**GoTriangle**  
**GoTriangle Durham Bus Stop Construction (Group J)**  
**IFB NO. 24-006**  
**Questions and Answers / Pre-Bid Meeting Minutes**

**Pre-Bid Minutes**

SITE NO.  
**932**

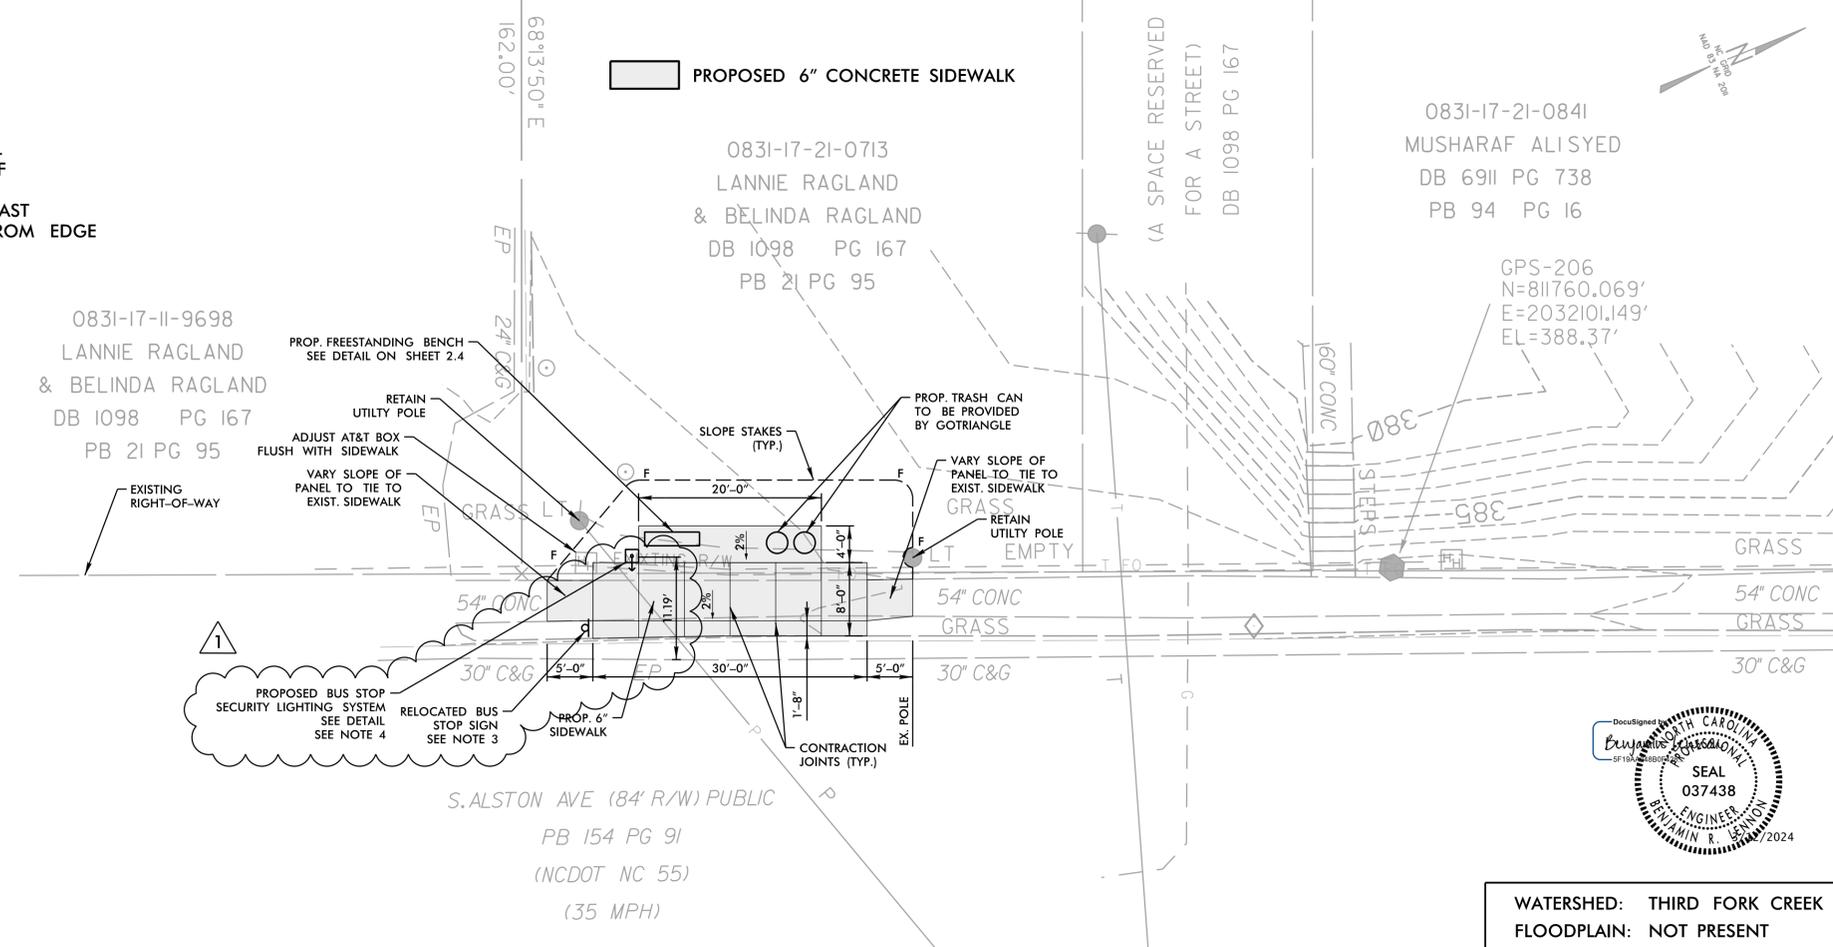
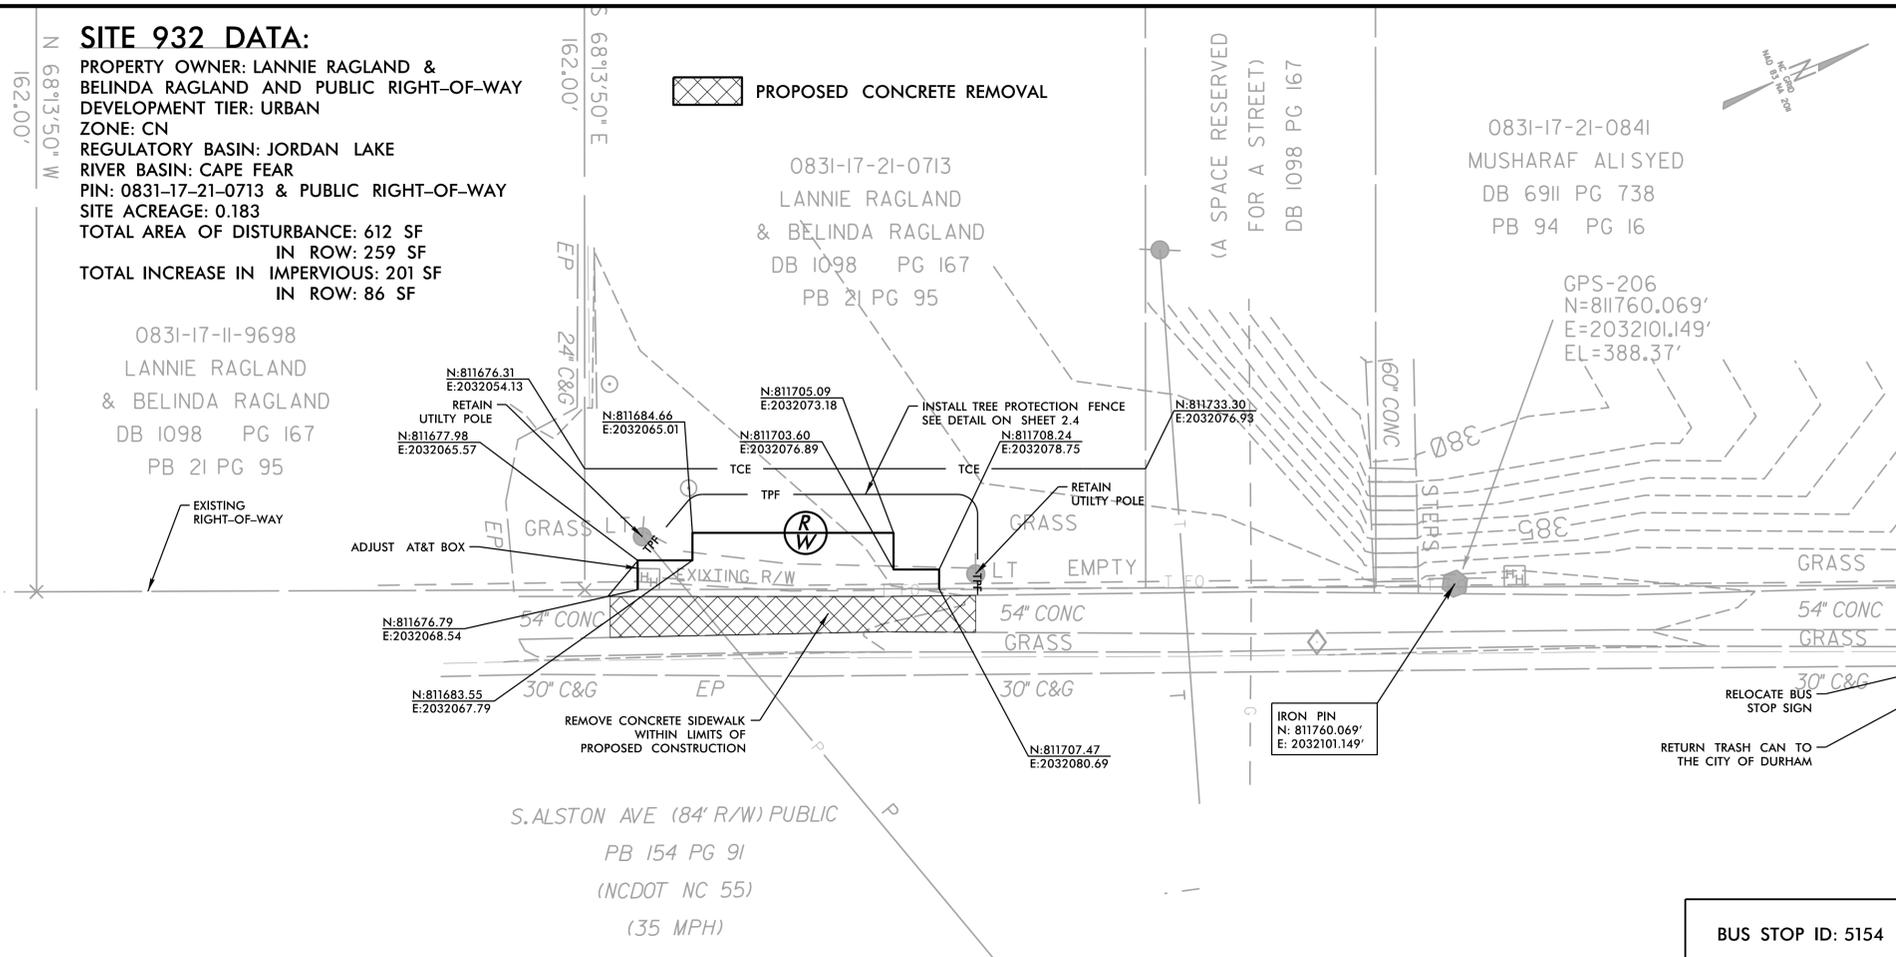
- ii. Rick stated Alston Ave have elevation/topo challenges and wanted to ensure the design of bus stops takes this into consideration.
- d. Willie Reid

REVISIONS	DATE	DESCRIPTION
1	3/12/2024	RELOCATED SECURITY LIGHTING SYSTEM FROM BUS STOP SIGN POST TO A SEPARATE POST

The revised plans for sites 619, 912, 932, and 944 all have security lighting systems on separate posts from the bus stop sign as such sheet 2C-3 includes the details for security lighting installation.

SITE NO.  
**944**

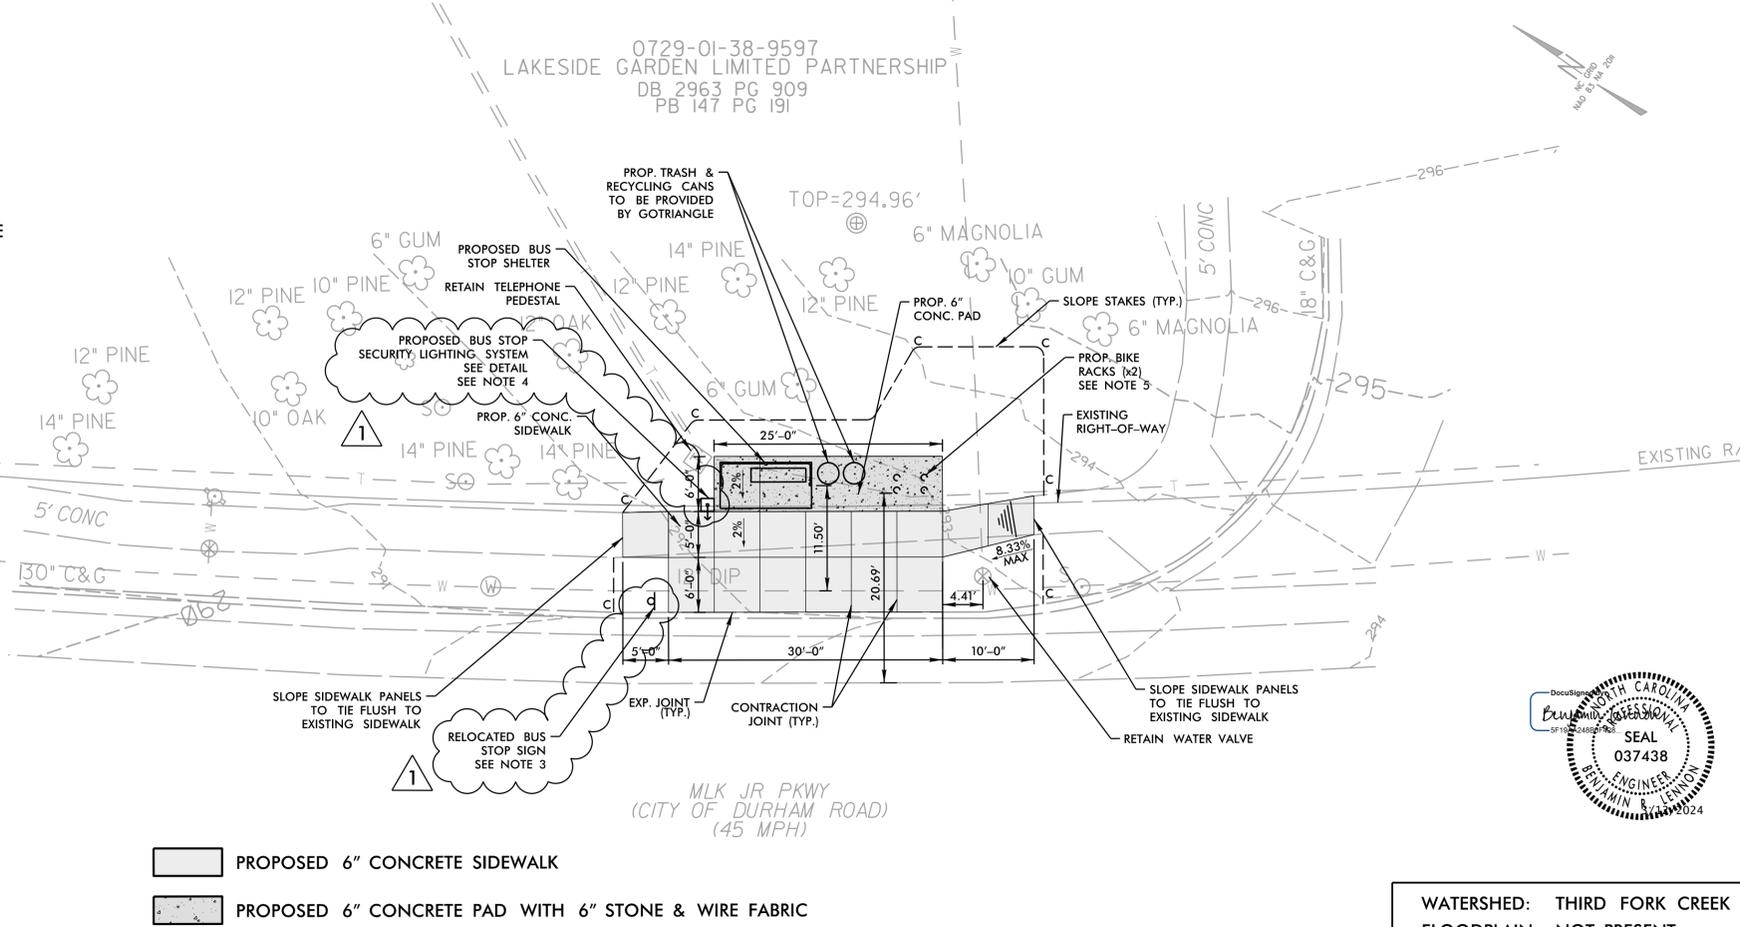
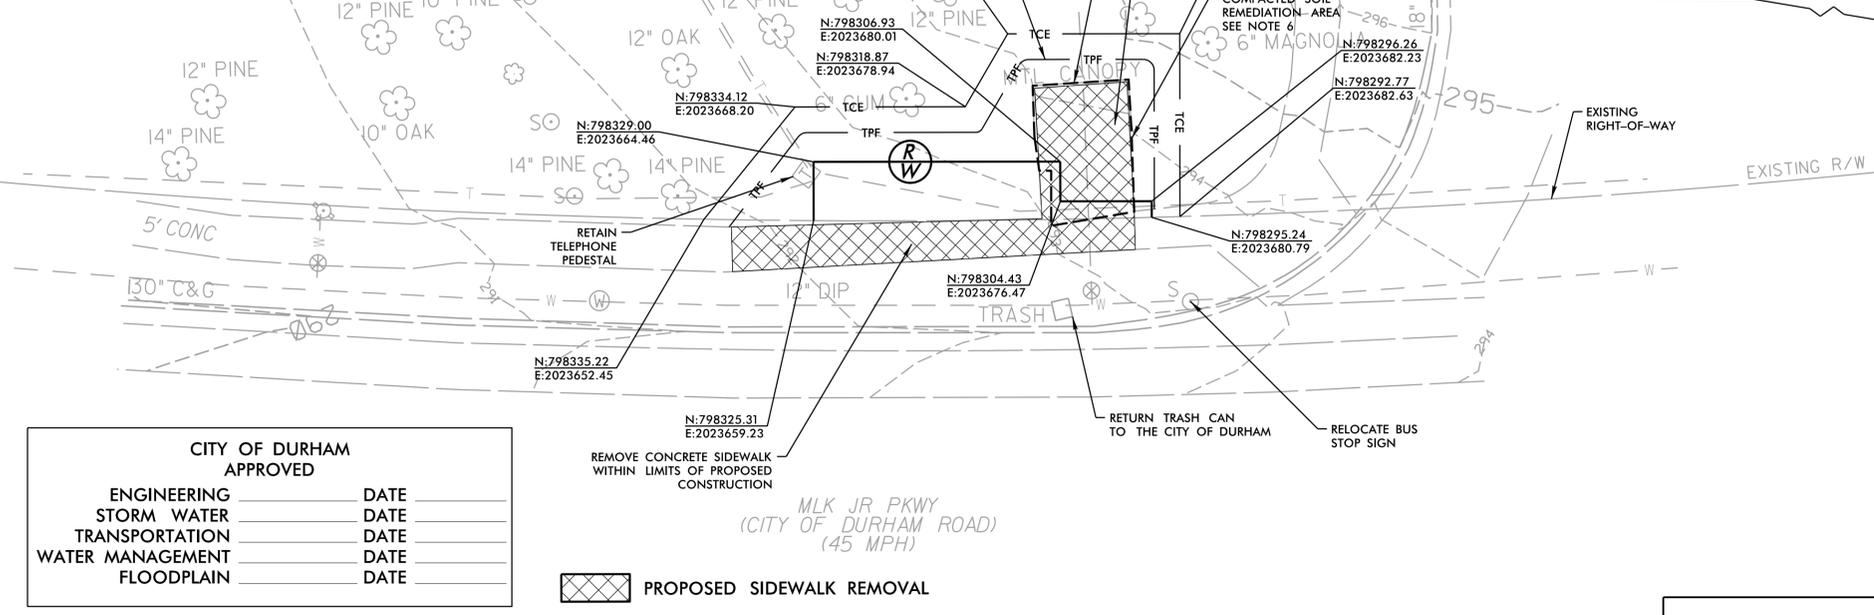
REVISIONS	DATE	DESCRIPTION
1	3/12/2024	RELOCATED SECURITY LIGHTING SYSTEM FROM BUS STOP SIGN POST TO A SEPARATE POST
